T-MOBILE PHII SWITCH EXPANSION

SITE PLAN AMENDMENT

LOT 1, BLOCK 2, TOWER CENTER FOR INDUSTRY SUBDIVISION FILING NO. 2

4 FENCE ELEVATION-TYP

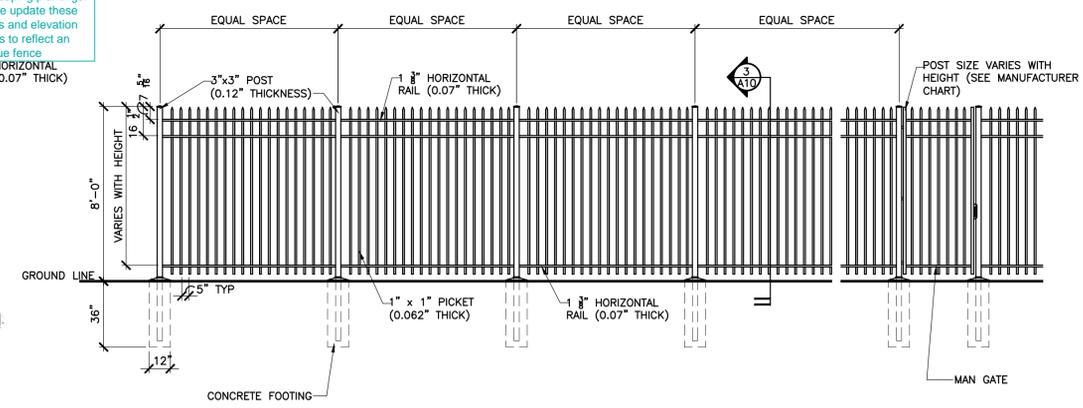
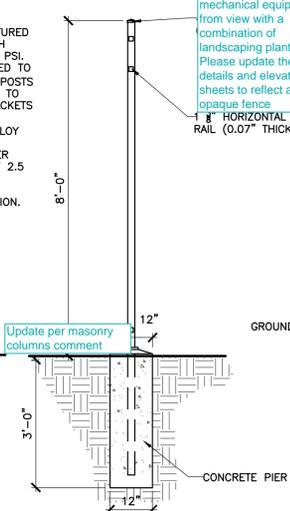
Update the notes per the fence comments.

The fence style must be opaque to screen some of the mechanical equipment from view with a combination of landscaping plantings. Please update these details and elevation sheets to reflect an opaque fence.

Update per masonry columns comment

SPECIALTY WOOD PRODUCTS
APPROVED SP 2006-6019-00
LANDSCAPE PLAN
EXISTING CONDITIONS
(SEE MODIFICATION ON SHEET 5 OF 8)

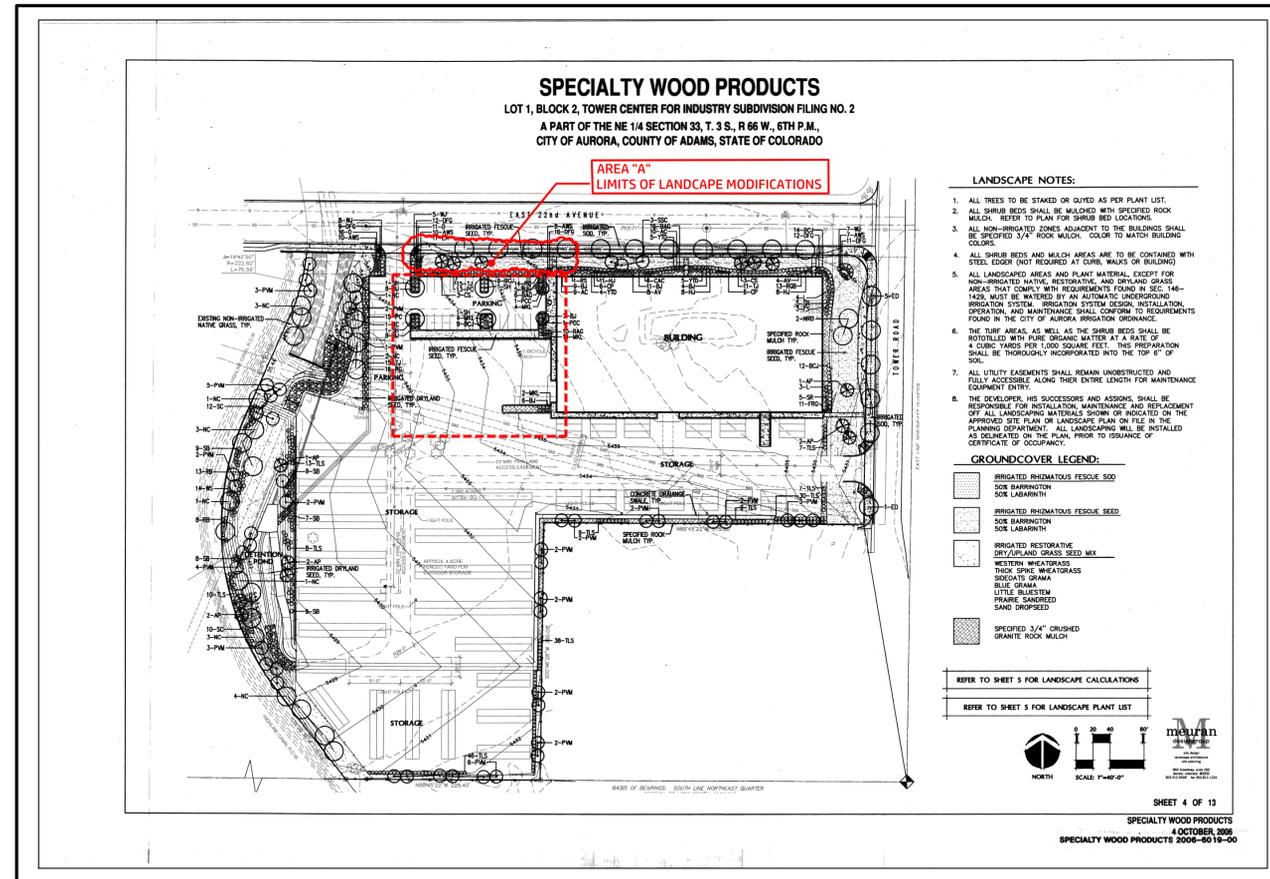
Include mitigation value and inches listed in the comments section of the review and add to the tree mitigation table. Any tree that is removed from this site will either require replacement within the landscape or be mitigated through payment to the Community Tree Fund. Tree mitigation is always above and beyond the Landscape Code requirements.

Added mitigation values, etc.

TREE MITIGATION & LANDSCAPE AREAS OF MODIFICATIONS (SEE SHEET 5 OF 8)

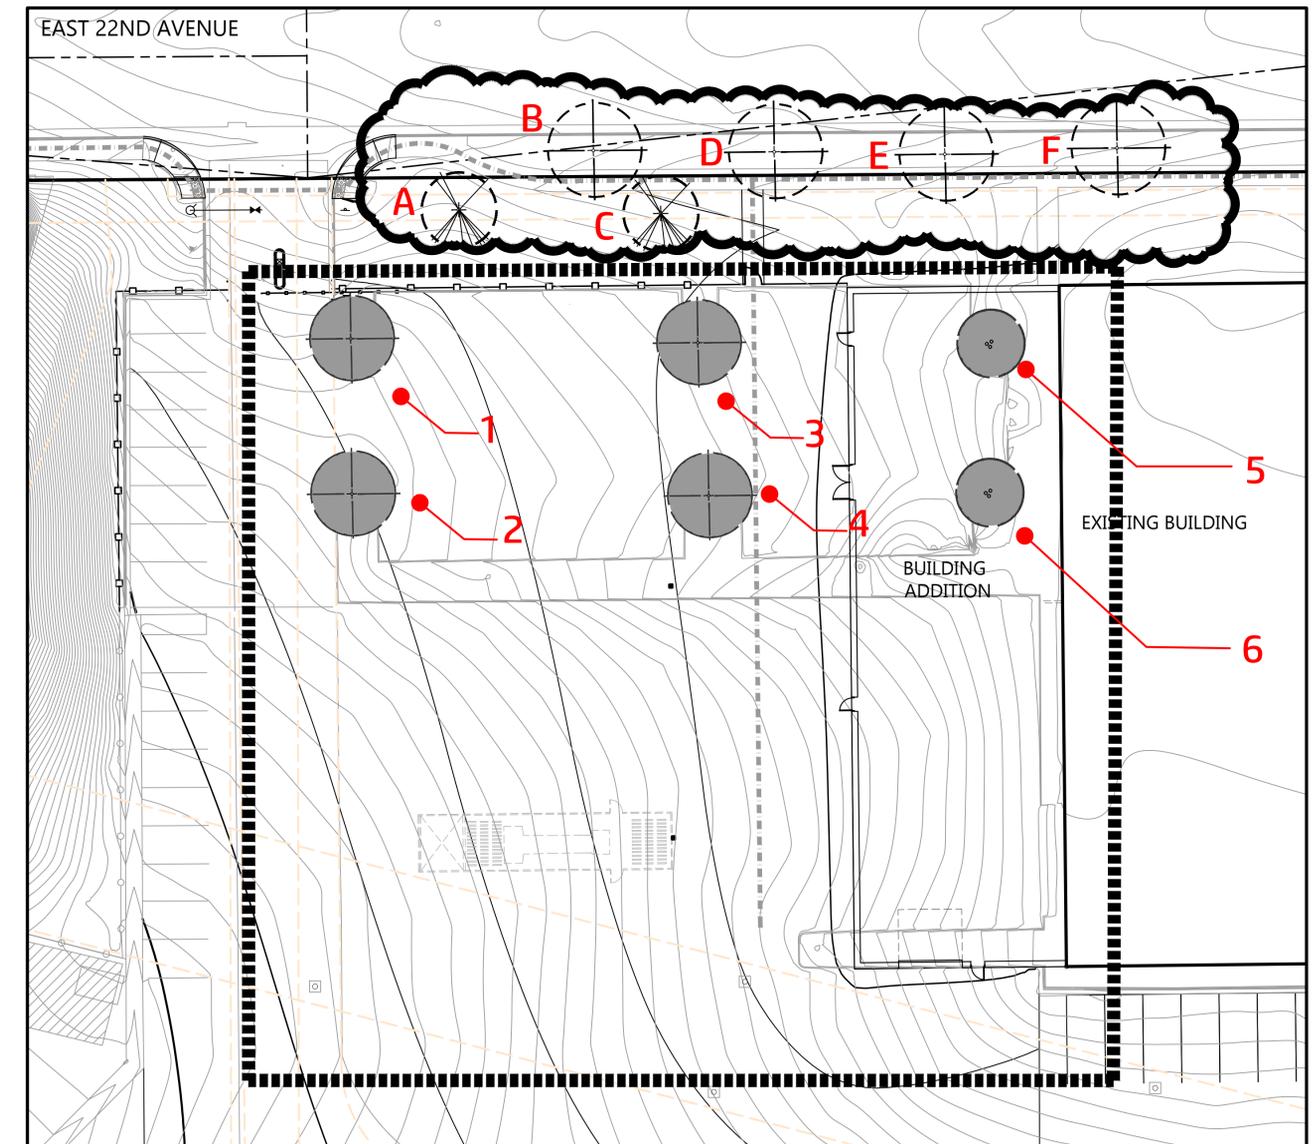
Indicate on the tree mitigation plan how mitigation will be achieved. If trees will be planted on the site, please show a symbol indicating trees that are specific to tree mitigation.

Added to mitigation plan.

1 GENERATOR YARD AND PARTIAL BUILDING SOUTH ELEVATION
SCALE: 3/16"=1'-0"

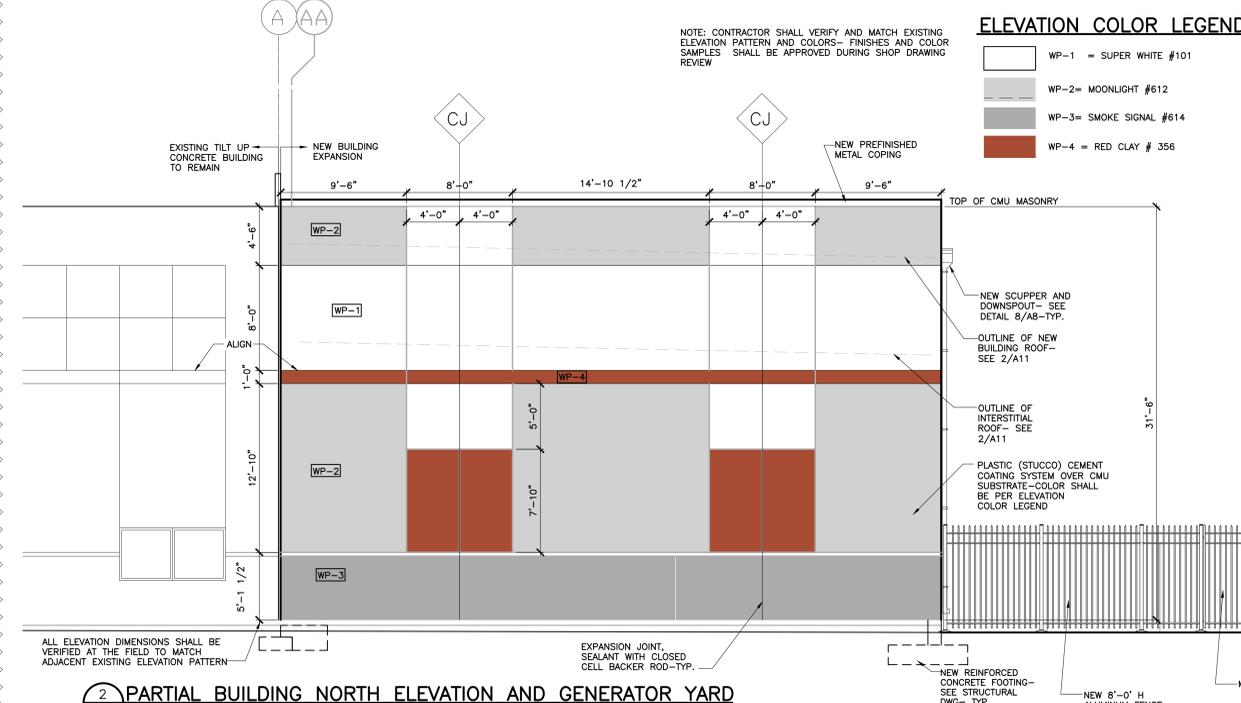
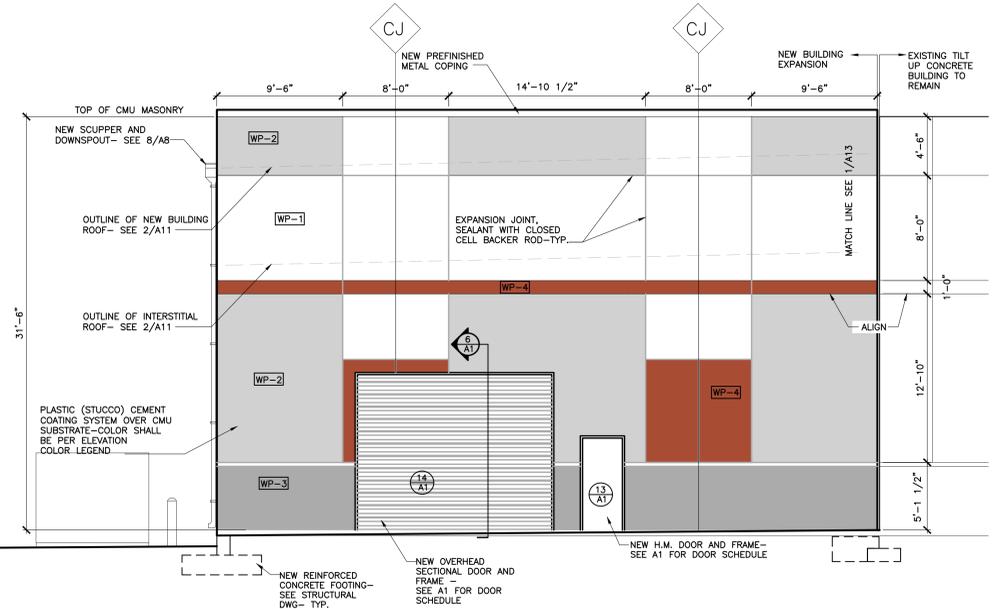
Label the height and length of the proposed generator

Specifically on the generator facing the right-of-way, is there any way to add facade material as screening? This would be only be applicable on the generator side facing north.

Approximate height and width added; to be verified by vendor submittal.

These generators are supplied by the tenant and aren't available with a facade. The enclosures are custom-designed, sound-attenuating, and are constructed with an aluminum exterior shell. Color will be selected to match the white building facade.
